UNITED STATES PATENT AND TRADEMARK OFFICE

APPLICATION NO.	FILING DATE	FIRST NAMED INVENTOR	ATTORNEY DOCKET NO.	CONFIRMATION N
10/019,650	01/03/2002	Haruko Toyoshima	0445-0316P	9924

Office Action Summary

DETAILED ACTION

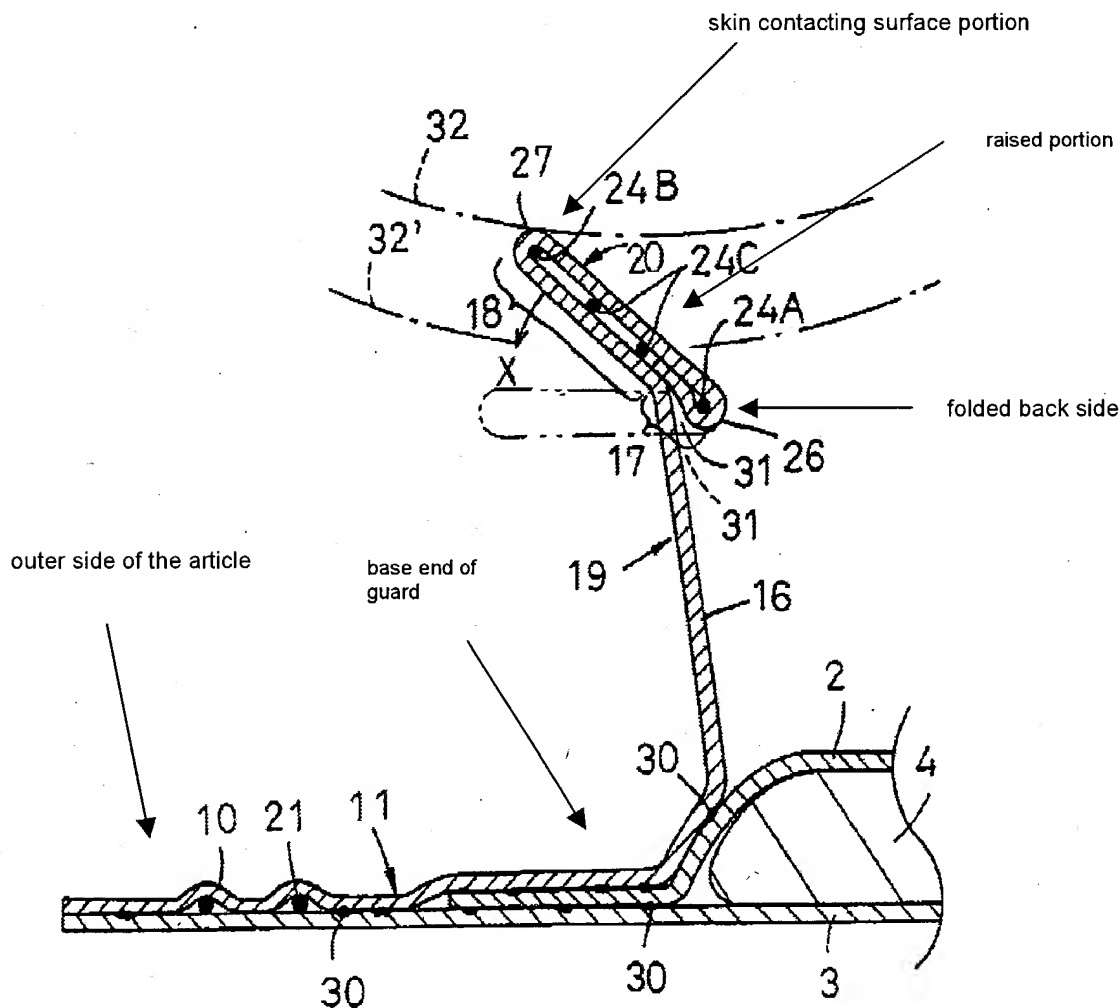
substantially oblong (4), and is providing on longitudinal opposite sides thereof with a pair of right and left elastic member-carrying three-dimensional guards (figure 2), wherein the three-dimensional guards each as a skin contacting surface portion (figure 3) formed by folding back a side on a free side towards the outer side of the absorbent article, and said elastic members are respectively disposed and fixed to (i) said skin-contacting surface portion and to (ii) an approximately width widthwise central portion of a raised portion, wherein the raised portion is located between the skin contacting surface portion and a base end of the three dimensional guard as set forth in figure 3.

As to claim 2, Yoshioka discloses an absorbent article wherein a total width of the elastic member disposed on the skin contacting surface portion (24B, 24C, 24A) is larger than a total width of the elastic member disposed on the raised portion (30) as set forth in figure 3.

With reference to claim 6, Yoshioka discloses an absorbent article wherein the skin contacting surface is folded back along the elastic member at a part of the location of the elastic member nearest the raised portion as set forth in figure 3.

With respect to claim 5, see the rejection of claim 4. Any portion of the area designated 11 may be considered a leg portion having no leg gather. If the raised portion is bisected, the lower half (which is considered the area above reference numeral 16 in figure 3) will have a larger stress than the upper half portion (the area beneath reference numeral 16 in figure 3) for the same reasons listed above.

In response to the applicant's argument that Yoshioka does not provide for an absorbent member having a skin-contacting surface portion formed by folding back a side on a free side towards the outer side of the absorbent article, the examiner disagrees and refers to figure 3 shown below.

Additionally, the examiner refers to annotated figure 3 to show the interpretation of the elements of Yoshioka by the examiner. The area just below the skin contacting surface to just below the area showing the folded back side is considered the "raised portion". As shown, the elastic members (24A, 24B, 24C) are disposed and fixed to the skin contacting surface portion and to an approximately widthwise central portion of a raised portion wherein the raised portion is located between the skin contacting surface portion and a base end of the guard.
